Gillig Campaign ID Number: 06V-427

*Gillig has decided that a defect which relates to motor vehicle safety exists in buses equipped with Cummins ISC and ISL engines manufactured between August 2003 and March, 2006.*

**Subject:** ISC/ISL CM850 Fuel Line Bracket

**Number:** C0610

Bracket Kit Part # 4937500

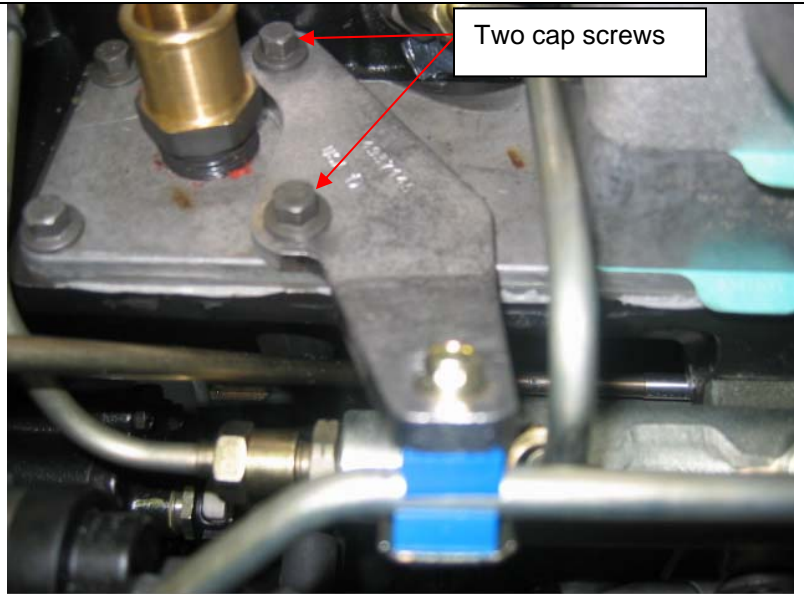
Upfit this bracket on the high pressure fuel line that supplies the rail with fuel from the high-pressure pump on C- and L-Series engines equipped with the CM850 Fuel System.

A new fuel line must be installed when installing the bracket.

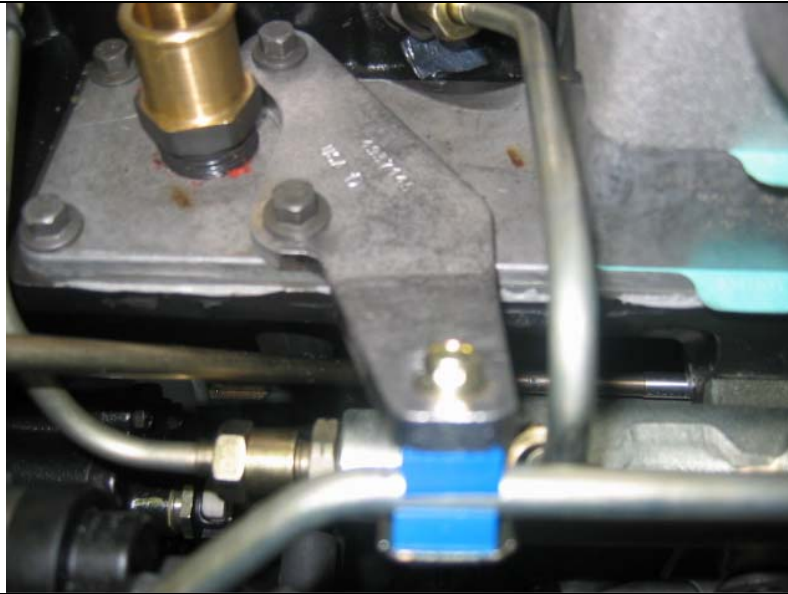
Remove the two (2) cap screws on the top of the intake manifold cover plate.

Install the bracket over the two (2) cap screw holes.

Initially, install the two capscrews finger tight.

Install the fuel line finger tight between the bracket isolators.

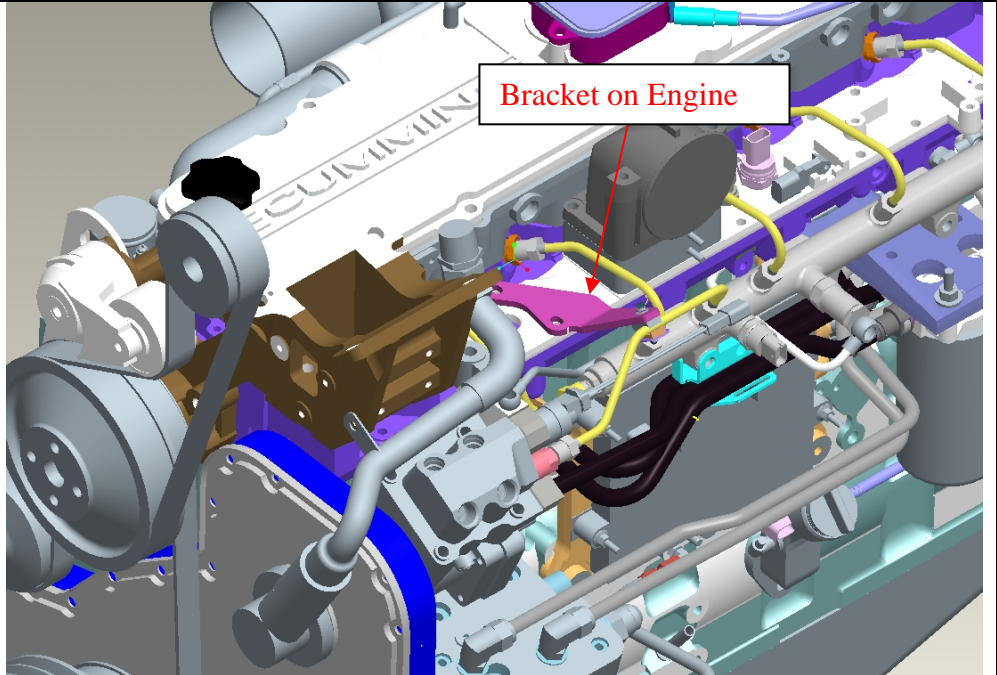
Then, install the bracket isolator capscrew finger tight.

Torque the fuel line.

Refer to Injector Supply Lines (High Pressure) Procedure 006-051 in the Troubleshooting and Repair Manual ISC, ISCe, QSC8.3, ISL and QSL9 Engines Manual Bulletin 4021418.

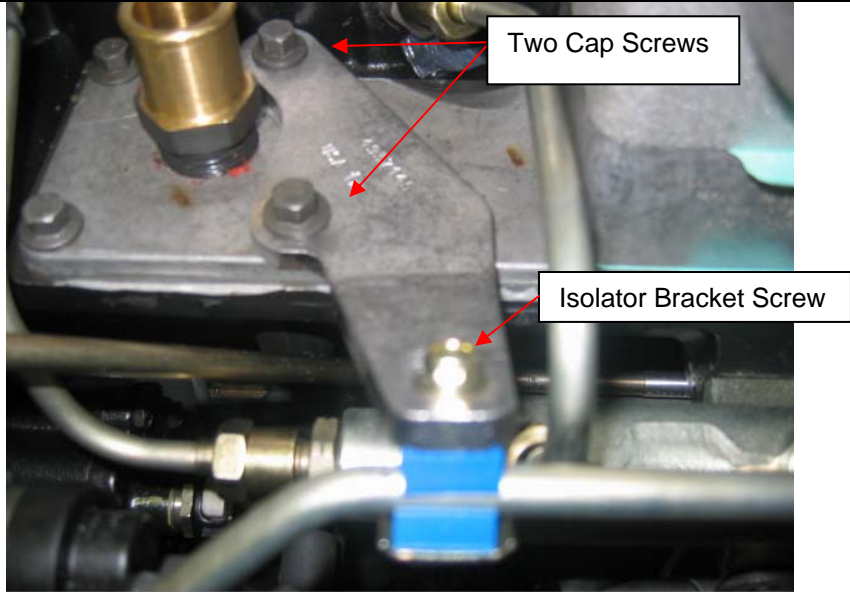
Tighten the bracket screws to the intake manifold cover plate.

Torque Value:  
24Nm [18 ft-lb]
